South Texas Project Electric Generating Station 4000 Avenue F – Suite A Bay City, Texas 77414

September 28, 2009
U7-C-STP-NRC-090163

South Texas Project
Units 3 and 4
Docket Nos. 52-012 and 52-013
Response to Request for Additional Information

Attached are the responses to the NRC staff questions included in Request for Additional Information (RAI) letter number 301 related to Combined License Application (COLA) Part 2, Tier 2, Section 17.4S, Reliability Assurance Program. This submittal completes the response to this RAI letter.

Figure 17.4S-1 Reliability Assurance Process

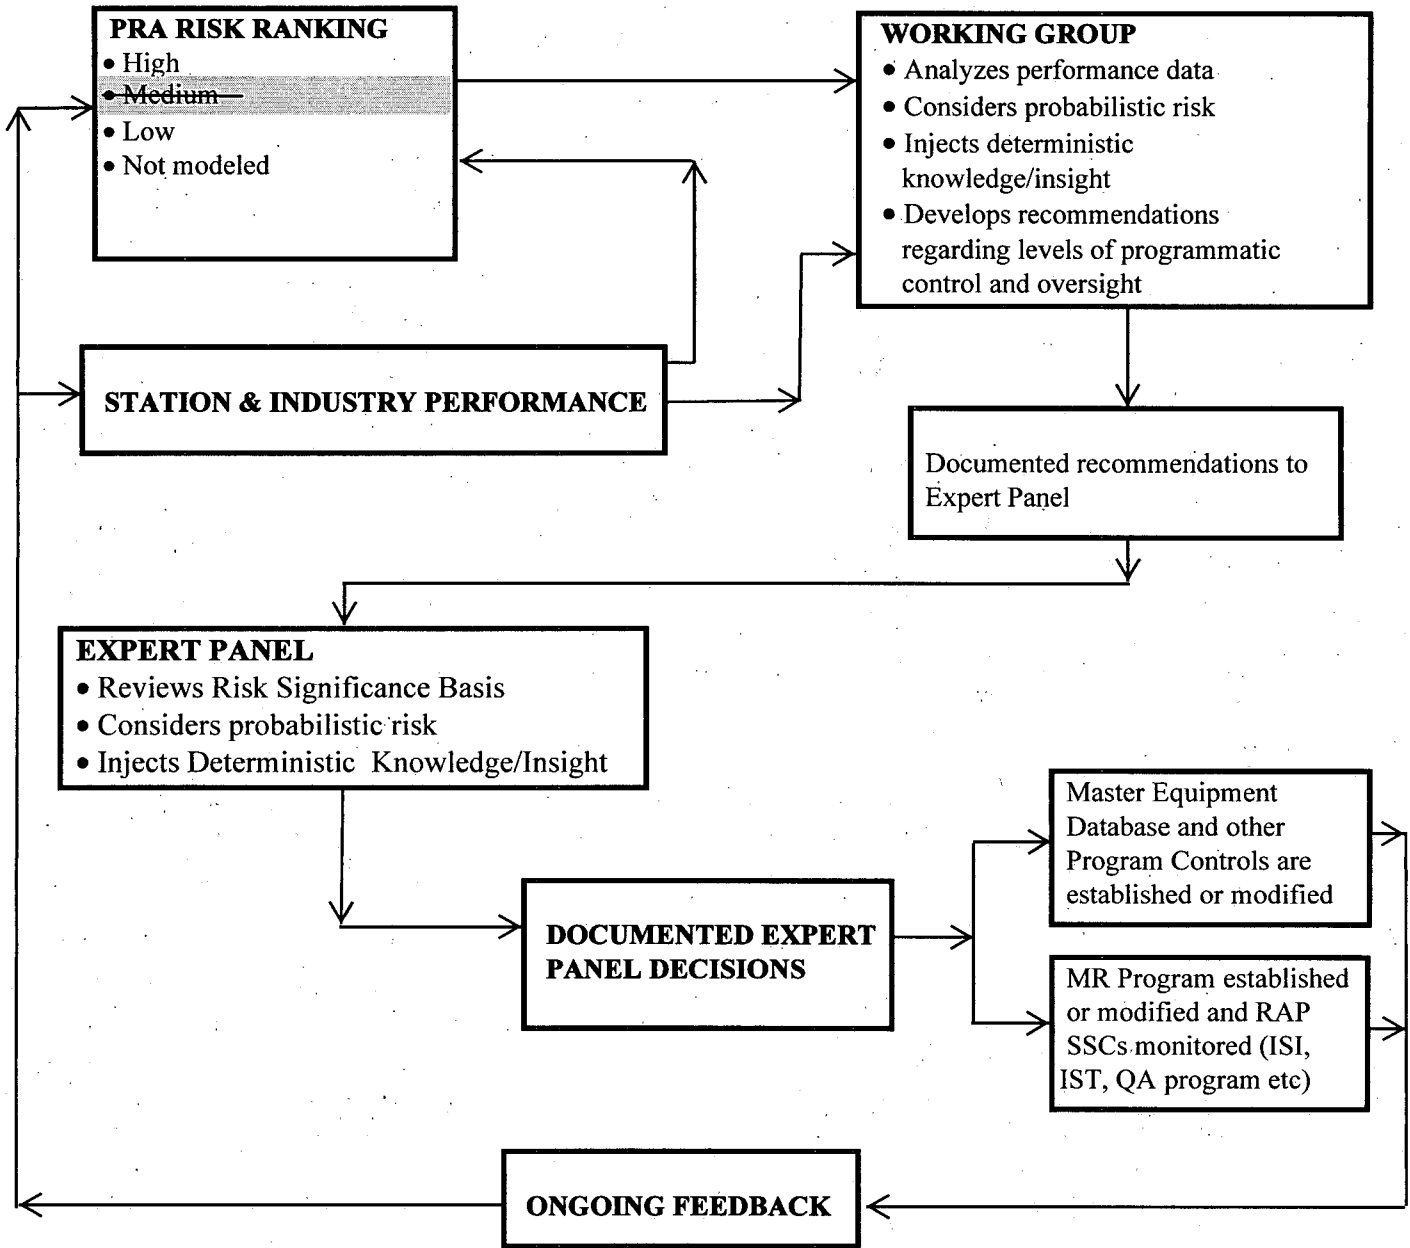
- As stated in Section 17.4S.1.4.1 of the STP FSAR, SSCs or functions having a FV importance greater than 0.005 or RAW greater than 2.0 would be included in the scope of D-RAP and subjected to the approved quality assurance program description (QAPD) referenced in Section 17.5S of the STP FSAR. This criterion is consistent with industry practices and guidance. However, the terms "PRA High" and "PRA Medium" used in Figure 17.4S-2 of the STP FSAR are not defined and no risk importance criteria are associated with these terms.

The term "PRA Medium" will be removed from Figure 17.4S-1 and from Figure 17.4S-2 (by deleting Figure 17.4S-2 since it only provided information already included in the text).

The qualitative risk analyses (e.g., SMA and FIVE) and PRA models for which risk importance measures are not available were evaluated in the ABWR DCD Appendix 19K. As part of D-RAP they will be addressed by the Expert Panel as shown in FSAR Figure 17.4S-1 (no revision to COLA Section 17.4S.1.4 is required to reflect this).

As a result of this RAI response COLA Revision 3 Part 2, Tier 2, Section 17.4S will be revised as follows with changes indicated by gray shading (Figure 17.4S-2 was simply deleted):
